## **MEMORANDUM**

**RE:** Percolation Certification Plan Comments:  
13942 Clarksville Pike – *El Sawi Property*

**13942  
CLARKSVILLE ROAD**

TITLE:  
**PERCOLATION CERTIFICATION PLAN**

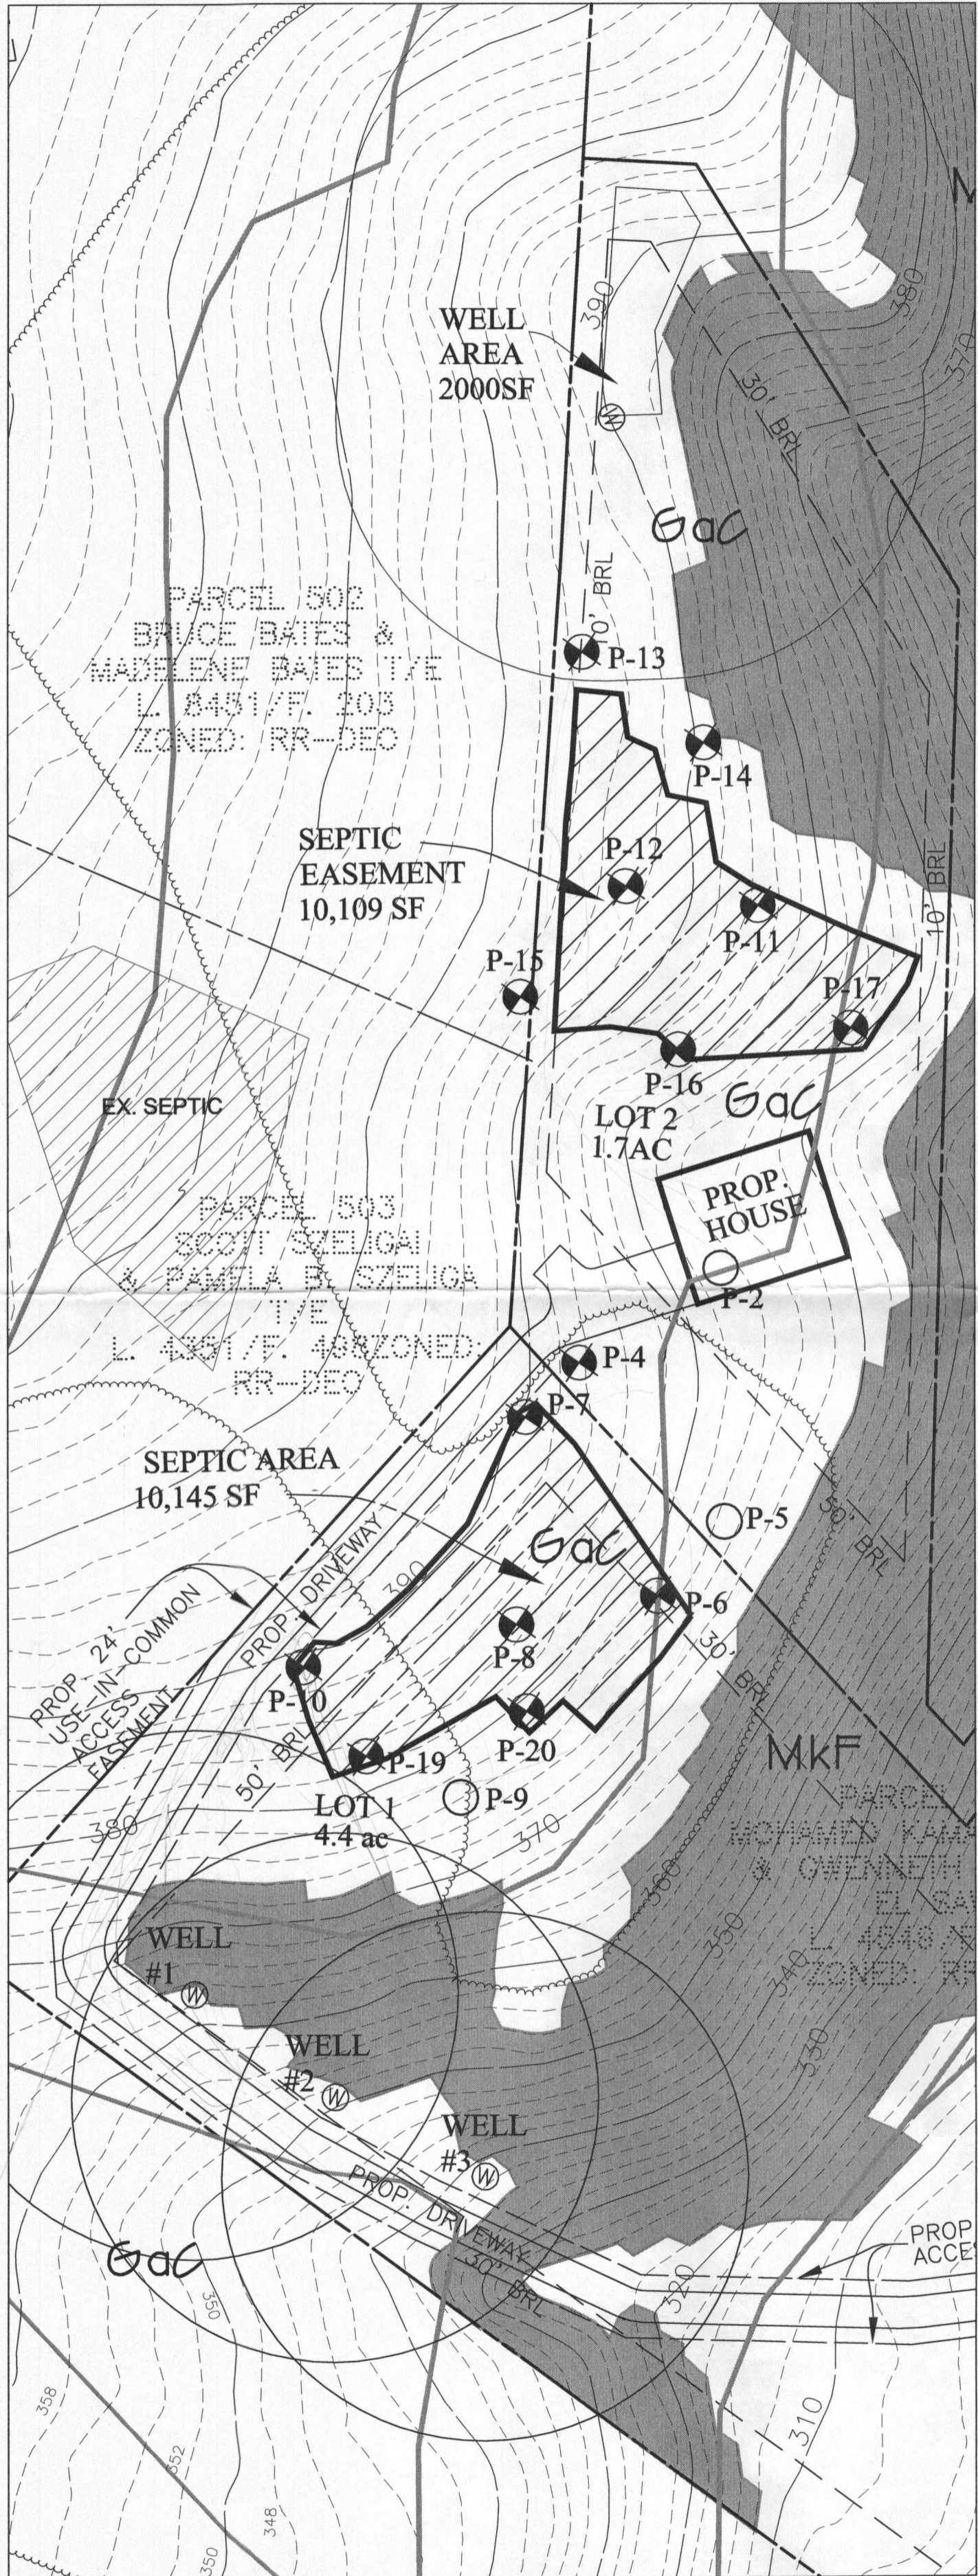
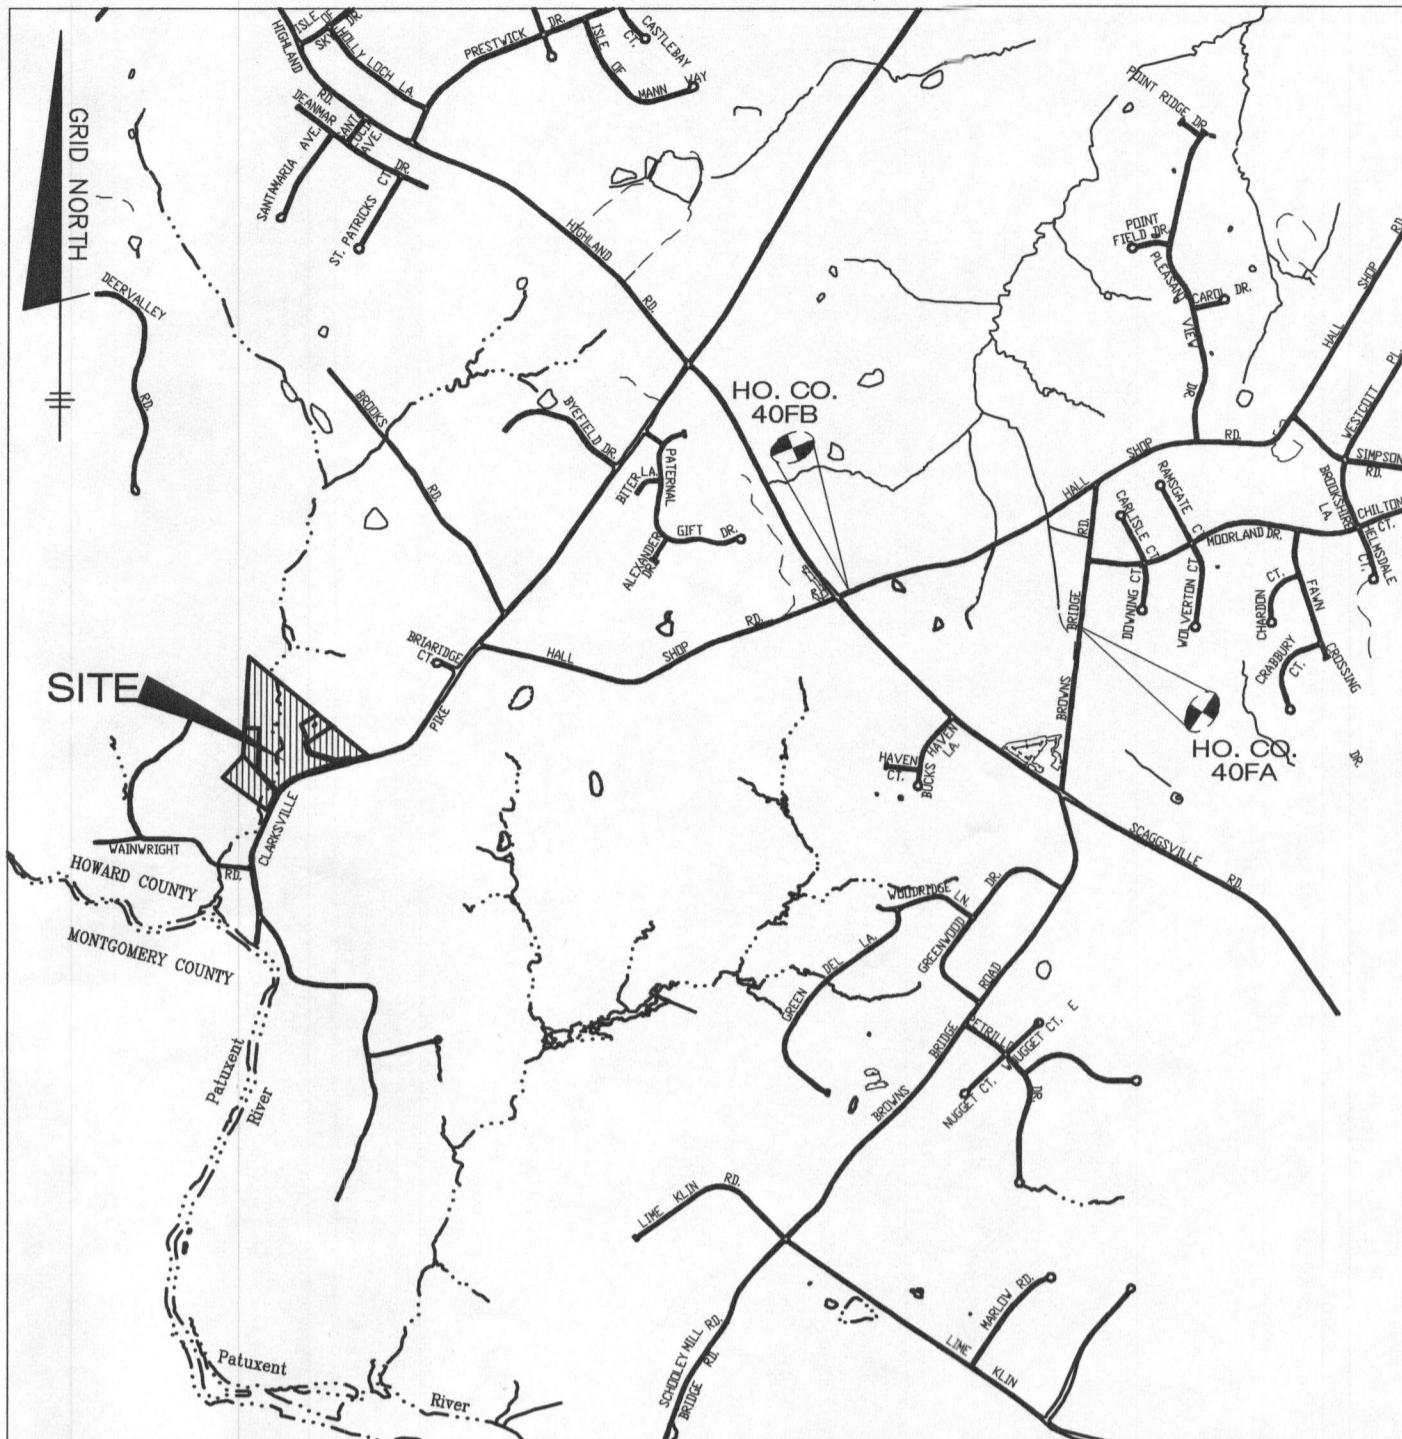
The following comments need to be addressed on the Percolation Certification Plan. Please revise and resubmit for review:

1. Newly installed septic system needs to be shown on the perc cert plan as per the completed as-built. BAT unit and pump tank may be encroached by the proposed drive.

2. Label plan "Subdivision" or indicate a purpose statement.
3. Proposed well site locations 1, 2, and 3 on Lot 1 need to be revised to meet 100' from septic and 200' down-gradient from septic. Move to add 1500ft<sup>2</sup> well box in far southwest corner of property on Lot 1. Proposed drive to Lot 2 may need to be adjusted some.

4. Add note to state on Lot 1, a 'sleeve' will be installed under drive prior to drive installation for proposed well line install. Turn-ups will be installed at either end of the sleeve as to serve as markers.

5. Add note to state Septic Reserve Area (SRA) for Lot 1 must be fenced off and protected prior to proposed drive installation. Protection devices (fencing) must remain in place during the entire construction phases of Lot 2.

6. Add note to state on Lot 2 septic install will require Low Pressure Dosing (LPD).
7. Please add on plan proposed grading for the drive-way install around Lot 1 SRA.

8. On Lot 2, please show the well line proposal to the house. Must meet 10' setback from the SRA. If not, note to state well line on Lot 2 must be sleeved within 10' of SRA.

1. The existing septic tanks are shown based on the painted locations previously provided by the Health Department on the property.
2. The project is now titled as "subdivision" in the project block.
3. The replacement well #3 has been relocated to the southwest corner. The other 2 locations are not down-gradient of the septic easement but 100' adjacent to the easement.
4. A note has been added on the plan and in the general notes as requested.
5. The fencing note for Lot 1 is provided in the general notes.
6. The LPD note for Lot 2 is provided in the general notes.
7. The conceptual grading for the proposed driveway is now provided.
8. The approximate location of the well line for Lot 2 is now shown. A note is added to the plan and in the general notes that a sleeve must be provided where the line is within 10' of the SRA.
